PROJECT
 17049
 407-411 KING STREET
 WEST MELBOURNE VICTORIA 3003

TP number	Description of Proposal	Decision & Date of Decision	Officer Comment
TP-2016-398	Partial demolition, buildings and works to construct a multi storey building to be used for the purposes of residential hotel, dwellings and licensed food and drink premises (restaurant and cafe licence) (excluding hotel and tavern) on ground level, reduction in car parking and bicycle facilities requirements, waiver of the loading bay requirements and construction and display of business identification signage	Refusal 13 April 2017	<p>Proposal sought approval to carry out partial demolition and construct a contemporary 19 level building above to an overall height of 69.4 metres.</p> <p>An application under Section 79 of the <i>Planning and Environment Act 1987</i> was lodged by the permit applicant at VCAT against Council's failure to grant a permit within the prescribed time.</p> <p>Council formed the view that had a failure appeal not been lodged, Council would have refused the application as a result of significant concerns raised relating to heritage, built form and design matters.</p>

On 27 April 2018, the applicant form

DRAWING TITLE
NORTH & EAST ELEVATIONS

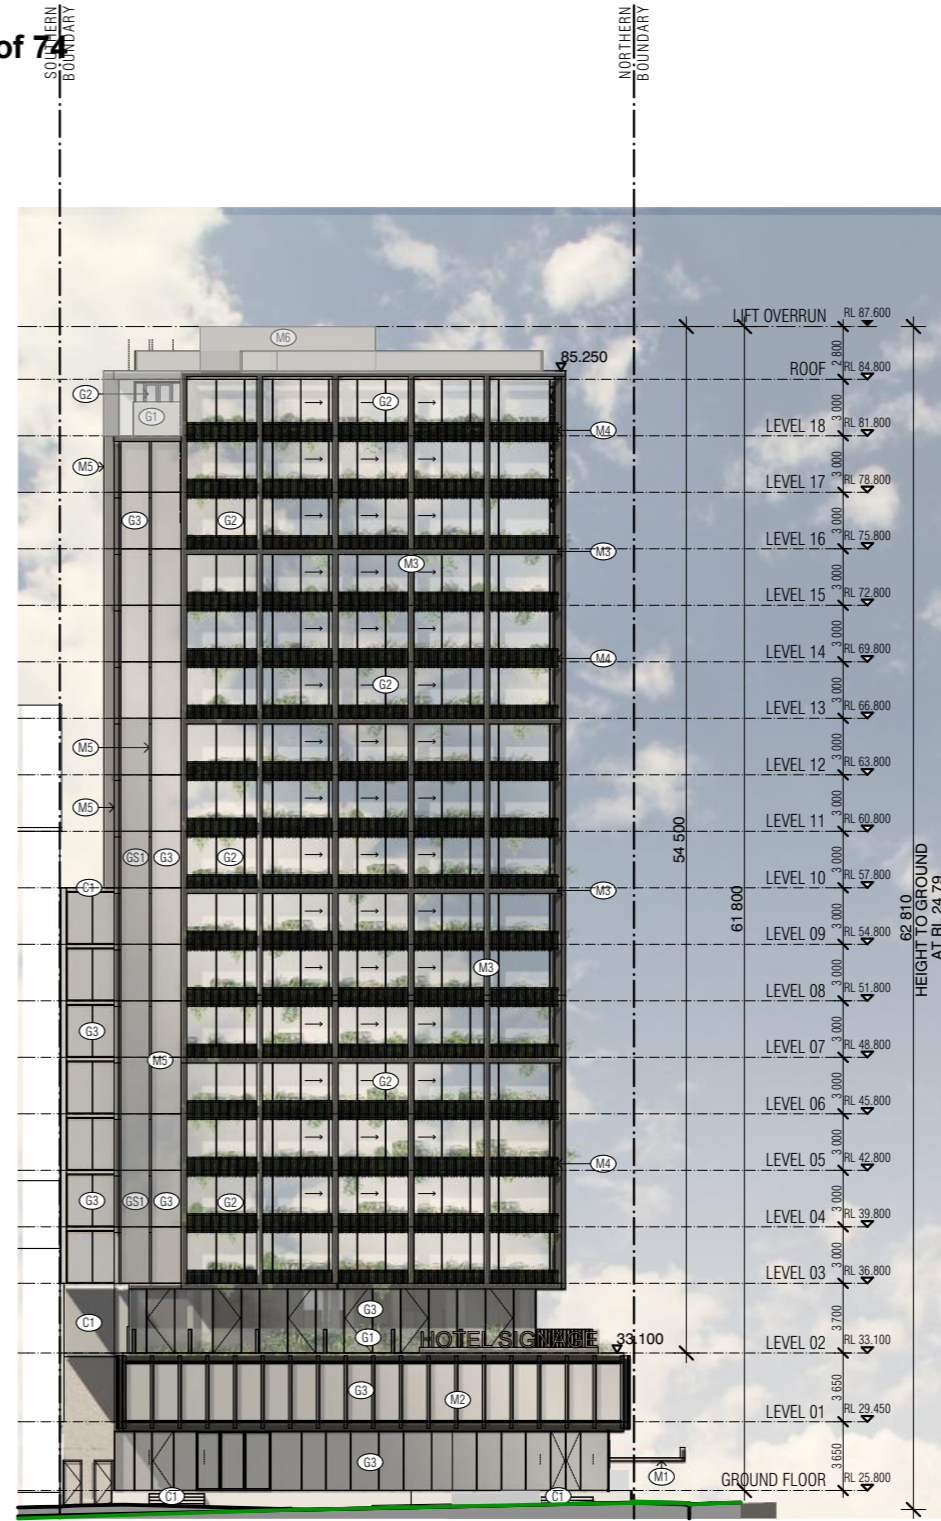
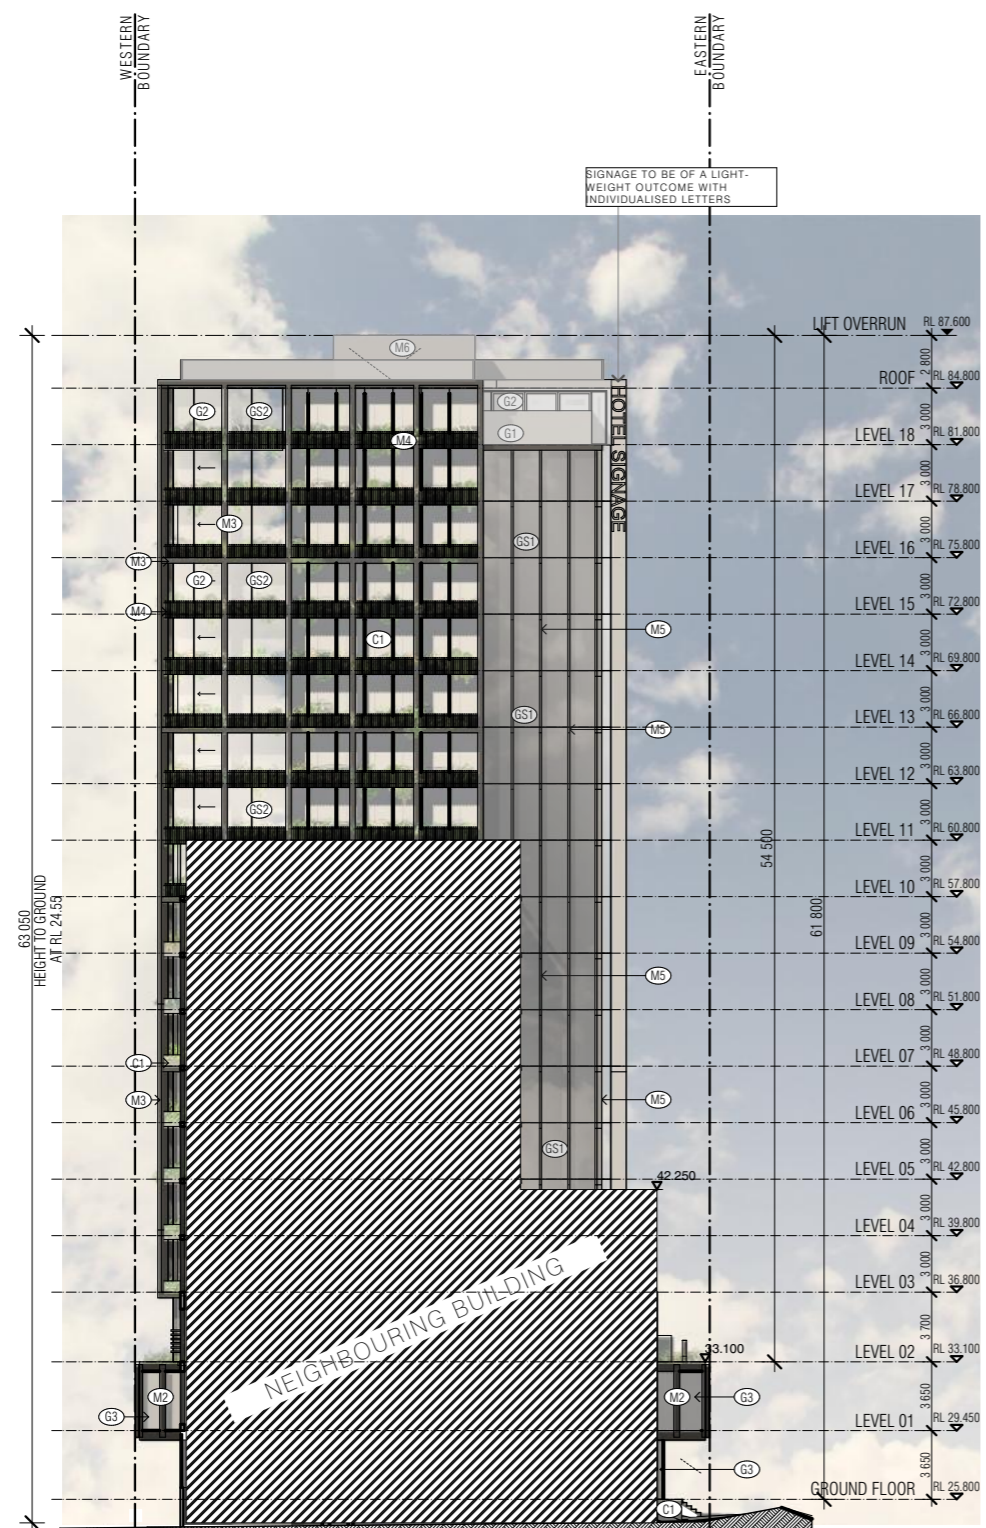
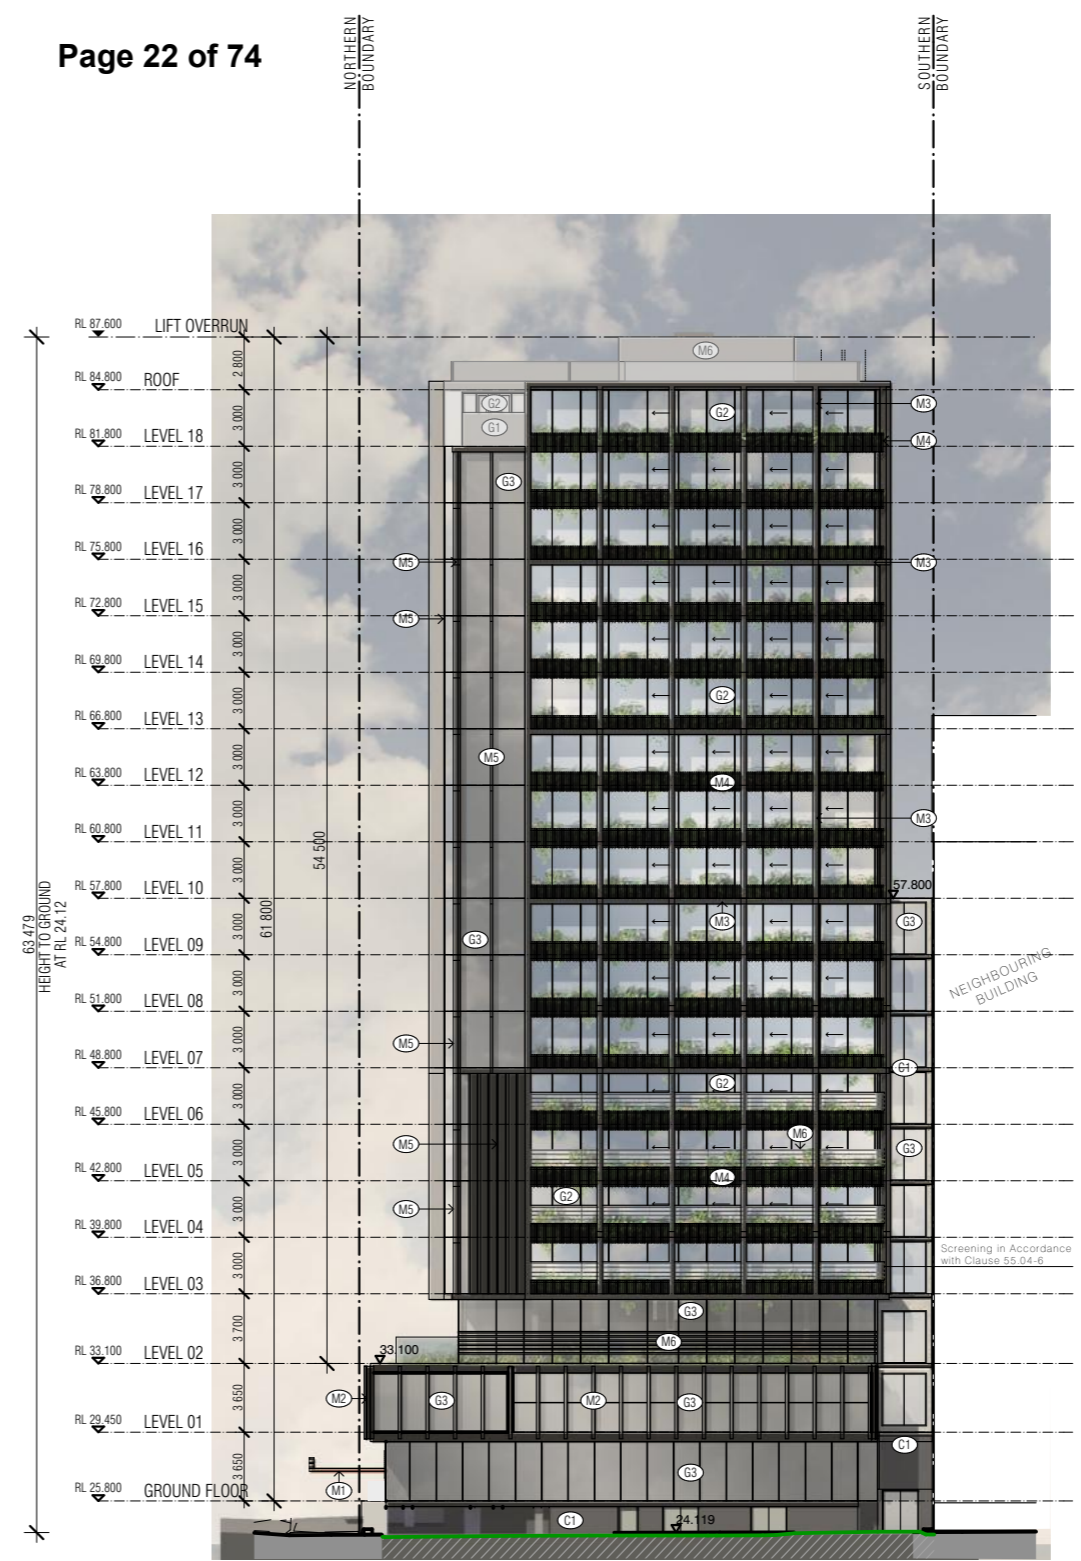
Compared to the previous refused scheme, the proposed architecture and design response is of a ‘superior’ quality’. However, it is the height at 60m which is considered excessive and will appear visually dominating when viewed from Flagstaff Gardens. This is inconsistent with the objectives of DDO33 which specifically intended “that the Flagstaff Gardens should maintain an open vista to its north and west away from the Hoddle Grid as opposed to the higher forms to the east and south where it directly interfaces it” (paragraph 47 of VCAT order *DCF 407 King Street Developing Entity V Melbourne CC [2017] VCAT 423, VCAT reference no: P19950/2016, dated 13 April 2017*).

It is therefore recommended that the height of the tower be reduced to a maximum overall height of 53m excluding the lift overrun. This will require the removal of two levels from the tower excluding the lift overrun. The construction of a 2.8m high lift overrun above the roof height of 53m which is setback from the boundaries will have minimal visual impact. While VCAT considered a 50m high building to be an appropriate response to the site, given the ‘high quality’ of the proposed tower when compared with the previous refused scheme, the additional 3m can be supported. It is considered that, when comparing the views to a 50m high building and a 53m high building from Flagstaff Gardens, there will be negligible difference in the visual impact.

1. Prior to the commencement of the development, including demolition and bulk excavation, two copies of plans, which are drawn to scale, must be submitted to the Responsible Authority generally in accordance with the plans prepared by Fender Katsalidas dated 13.04.2018, drawings no: TP099, TP100 to 108, TP200, TP201, TP300, TP250, TP251, TP252, TP270, SK001, SK002 but amended to show:

Figure 7: Proposed level 18 floor plan

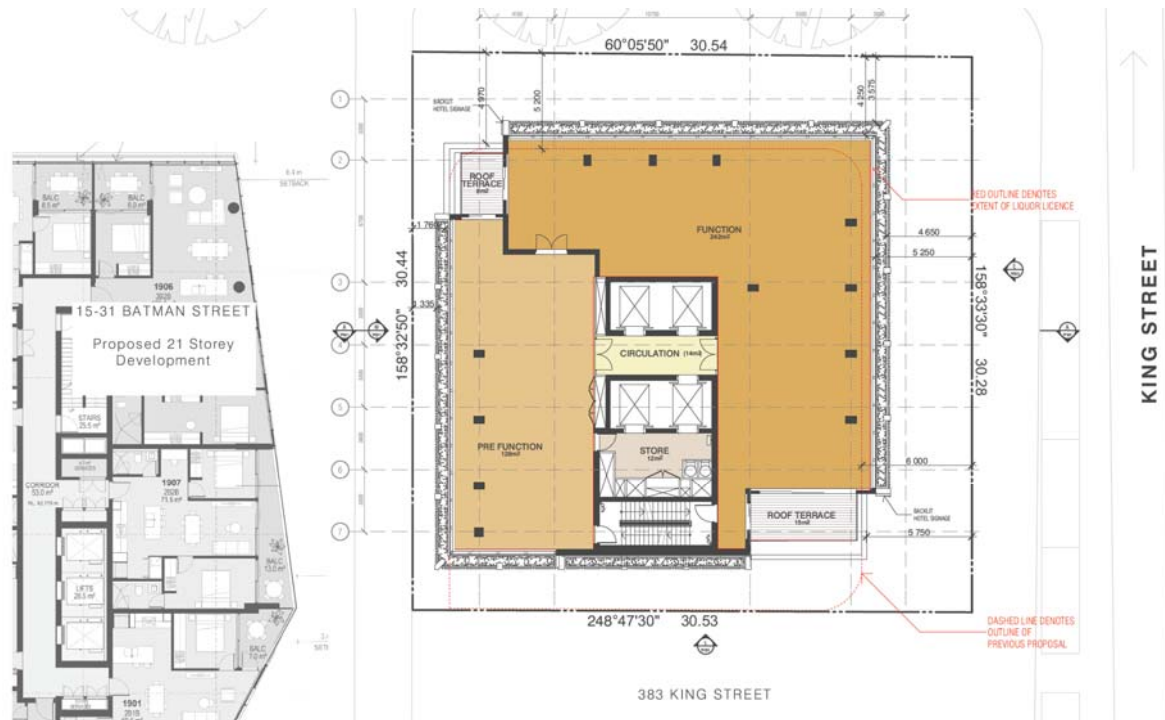
As depicted in figure 7 below, the licensed function centre use proposed on the rooftop comprises a pre-function space and outdoor spaces located in close proximity to sensitive uses; a residential apartment building located to the immediate west at 15 Batman Street, and the school located to the immediate south at 383 King Street.

It is proposed to consume liquor in these function spaces until 11pm and the maximum number of patrons allowed will be 255 at any one time. The 11pm closing time is consistent with the hours outlined in Clause 22.22. However, the policy discourages new licensed premises in the Mixed Use Zone where the predominant surrounding use is residential. While it can be argued that the surrounding uses are not predominantly residential, as mentioned above, the subject site has direct abuttal to a residential use.

The residents at 15 Batman Street have objected to the proposed function centre use. These adjoining dwellings have private balconies and habitable room windows directly interfacing the function centre. Concerns are raised with regards to the potential amenity impacts that the proposed function centre and associated on-premises licence may have on the neighbouring dwellings from the 255 patrons and the noise particularly in the outdoor terrace areas. The current application does not provide any details as to how patrons and noise will be managed to mitigate the amenity impacts to these adjoining sensitive uses. In addition, the internal layouts of these spaces are not shown.
